Decomposition analysis of water footprint changes in a water-limited river basin: A case study of the Haihe River Basin, China

MS No.: hess-2013-545

MS Type: Research Article

Figure 1. Location of study area (adapted from website of Haihe River Water Conservancy Commission <http://www.hwcc.gov.cn/pub/hwcc/static/szygb/gongbao2011/>)

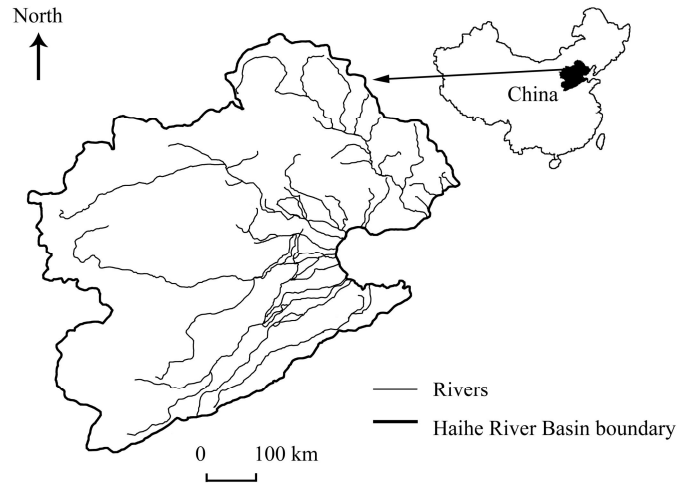
4 The title of 2.1 should be changed as Study area, and a location map should be supplemented in this part;

**Response:** Following this comment, we have changed the title of 2.1 to “Study area” (see page 4, line 21).

We have also added the location map as follows, which was adapted from website of Haihe River

Water Conservancy:

Figure 2. WFs in the HRB in 2002 (a) and 2007 (b)

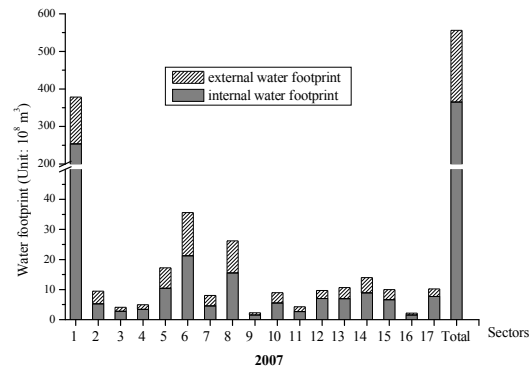
9 The name of X-axis and Y-axis in Fig.1 should be marked.

**Response:** The names of X-axis and Y-axis in Fig.1 (Fig. 2 in the revised version) were added. X-axis meant the number of sectors, and Y-axis meant their water footprints ( $10^8 \text{ m}^3$ ). The expanded details please see below:
